Stonington Harbor Management Commission

Special Meeting – October 7, 2019 Minutes by (Melanie Degler, Secretary)

2. Public Outreach Presentation by Bill Heiple, Sr Project Manager with StanTec, regarding the Breakwater: See attached presentation

Alternative 4 – Flat Crest

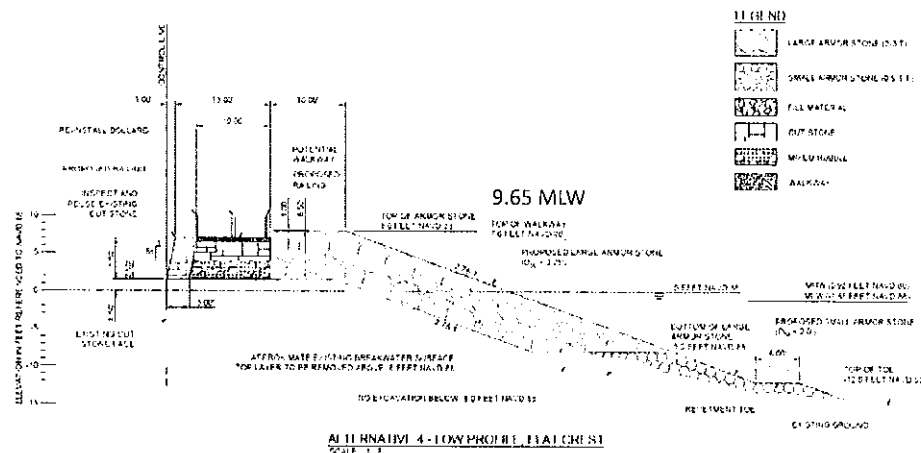
- Coast Guard Aid to Navigation at the end of the Breakwater is the responsibility of the US Coast Guard for all repairs.
- The last damage to the Breakwater was possibly caused by the 1938 Hurricane. No major damage has been seen in the last forty (40) years.
- StanTec Coastal Engineers recommend Alternative #4 without the step, but including the small walkway viewing area.

- Why do we need a viewing area that requires ADA requirements?
- Strong sentiment of a viewing area is wanted.
- Will the bollards from the historic photographs be included in the new design?

- We should ensure this Breakwater is fully ADA compliant, not just wheelchair accessible, such as including visual and hearing compliancy, if we choose to allow partial access to the Breakwater.
